Job Title	CHARTER HOUSE AND HORN YARD
-----------	-----------------------------

PROPOSED SOUTH EAST ELEVATION E02&3

project	originator	volume	level	type	role	number
3732 -	LJA -	E0 -	XX -	DR -	A -	05005

revision:	code	description:
	F	NMA PLANNING SUBMISSION

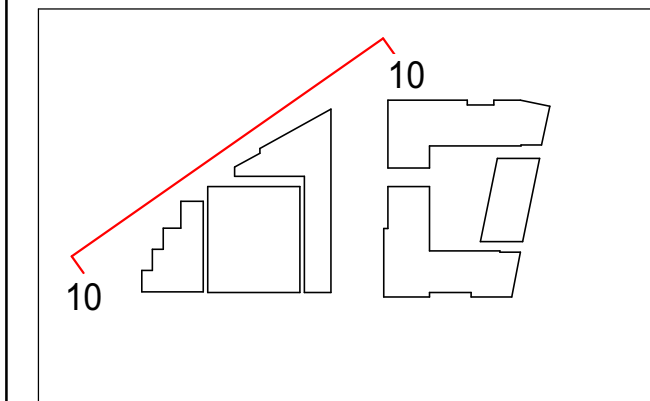
ELEVATIONS
CHANGE IN WINDOW POSITIONS FOLLOWING
CHANGES IN LAYOUTS OF UNITS.

CHANGES IN WINDOWS DETAIL TO ACCOMMODATE
CLEANING AND MAINTENANCE REQUIREMENTS.

CHANGES TO TERRACE BALUSTRADING TO
ACCOMMODATE FIRE SAFETY REQUIREMENTS –
UPPER LEVEL GLAZED CHANGED TO METAL.

CHANGES TO BALCONIES IN E03 FOLLOWING OVER SAILING STUDY – 1NO UNIT HAS HAD ITS BALCONY REMOVED MEANING THIS ONE UNIT WILL BE THE ONLY UNIT IN THE DEVELOPMENT WITHOUT ACCESS TO EXTERNAL AMENITY SPACE, IT WILL HOWEVER HAVE ACCESS TO THE SHARED INTERNAL AMENITY SPACE AT THE BASE OF E03.

CHANGES TO CAR PARK PARAPET TO
ACCOMMODATE GBC'S REQUIREMENT FOR
ADDITIONAL HEIGHT TO AVOID FALLS.

CHANGES TO PARAPET HEIGHTS TO ACCOMMODATE
ROOF BUILD UP AND FALL ARREST.

PLANS
INCREASED DISTANCE BETWEEN E01 TO THE OLD
MARKET. E01 MOVED SLIGHTLY NORTH.

COMMON AMENITY AREAS HAVE BEEN REDESIGNED
AND LOBBYS UPDATED.

CORES, COMMON CORRIDORS, AND UPPER LEVEL DUPLEXES HAVE BEEN ADJUSTED DUE TO FIRE STRATEGY REQUIREMENTS.

CHANGES TO ROOM LAYOUTS. SUBJECT TO THE ROOM SIZES MEETING THE RELEVANT LOCAL AND NATIONAL STANDARDS (INCLUDING THE 20% AFFORDABLE)

CHANGES TO CAR PARK LAYOUT TO IMPROVE CIRCULATION. CAR PARKING BAY ALLOCATION CHANGED TO INCREASE RESIDENTIAL BY 2 AND REDUCE PUBLIC BAYS BY 2. MOTORCYCLE BAY PROVISION REDUCED TO 8 (6 PUBLIC AND 2 RESIDENTIAL).
